WORK ORDER NON-CONFORMANCE / UPDATE

Item ID: D3394-3RG Accept ***N900040100*** Setup Start ***NS1***
Revision ID: Stop ***NS2***
Item Name: Lug
Start Date: 1/30/15 Start Qty: 24.00 ***24*** Cust Item ID:
Required Date: 2/20/15 Req'd Qty: 24.00 ***24*** Customer:
Reference:

DRAWING NO. D3394	TITLE LUG	REV. B	DART AEROSPACE USA, INC ENGINEERING ORDER		D.E.O. NO. D3394-B-2	SHEET NO. SHEET 1 OF 1	SCALE NTS
DRAWN 97	CHECKED SC	MFG. APPR. M	APPROVED MP		DE APPR. H		
DATE 11.05.02	DATE 11.05.09	DATE 11.05.09	DATE 11.05.09		DATE 11.05.09

D3394-1RG LUG (SHOWN)
D3394-3RG/-5RG LUGS (SIMILAR)
D3394-041RG/-043RG/-045RG LUG ASSEMBLIES (SIMILAR)

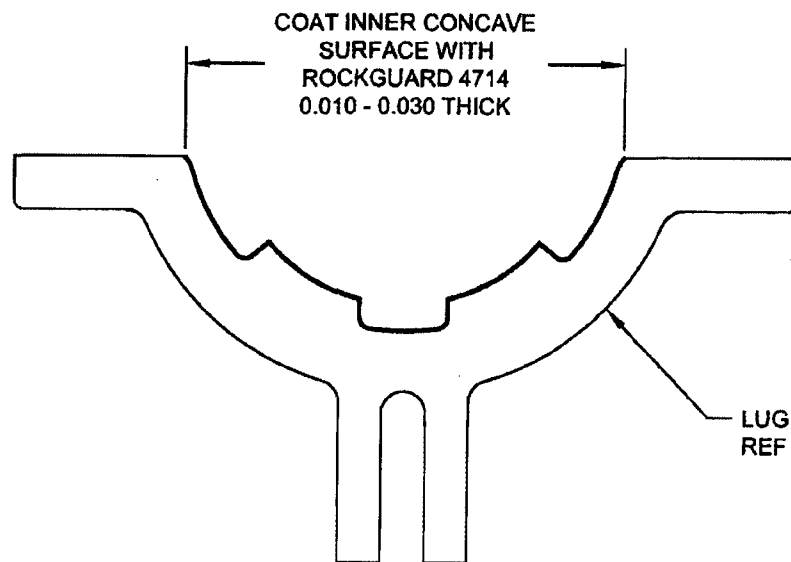
PURPOSE

ADD D3394-xRG OPTION

CHANGE

D3394-xRG MOUNTING LUGS ARE INDENTICAL TO D3394-x MOUNTING LUGS, HOWEVER AFTER FINISH, COAT INNER CONCAVE SURFACE WITH "PLUS ONE ROCKGUARD 4714" AS SHOWN BELOW.
